**Subject: MHI's Response to Summary of the NRC Staff Findings regarding MUAP-07005, "Safety System Digital Platform –MELTAC-, Revision 3"**

Response to Summary of the NRC Staff Findings regarding  
MUAP-07005, "Safety System Digital Platform –MELTAC-, Revision 3"

Figure 1 – Japanese Nuclear Quality Program vs. Appendix B Activities

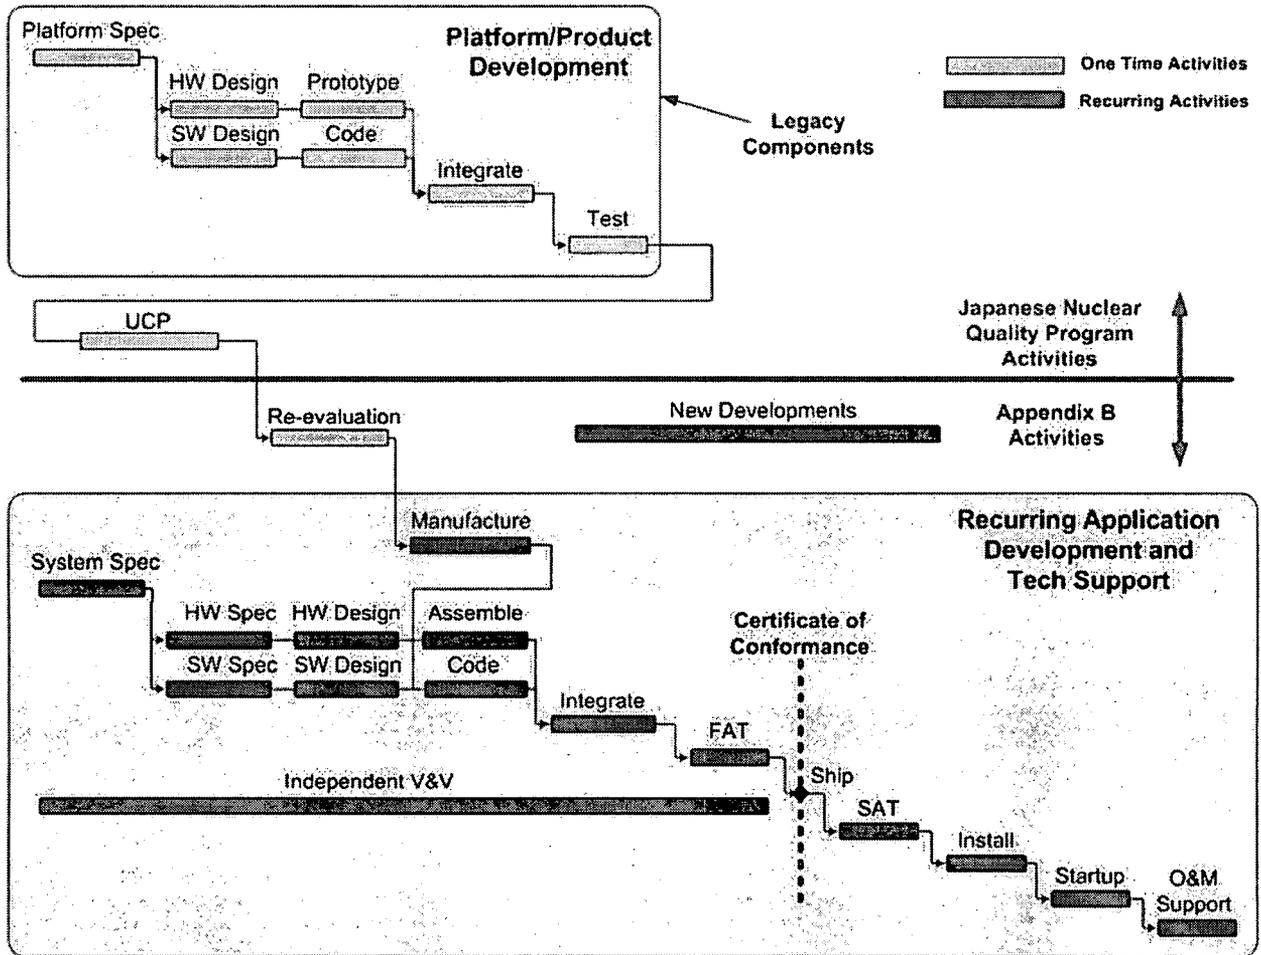
As explained in item 1(a) above, the purpose of MELCO's original UCP program was to compare the original MELTAC development to US NRC technical and quality requirements, and to compensate for any gaps. MELCO implemented the UCP in accordance with NPD Procedure Q-4102 "Safety System Digital Platform Quality Assurance Program" which was the basis for compliance to 10CFR50 Appendix B. However, the MHI QA audit of March 2009 identified deficiencies in MELCO's QAP, which has now raised NRC questions about the quality of the original UCP. To resolve this issue, we are taking the following actions:

Figure 1 clarifies the relationship between the MELTAC development activities conducted under their QAP to date, and the non-recurring re-evaluation activities and the recurring project activities which will be conducted under their new QAP (which will be fully comply with 10CFR50 Appendix B).
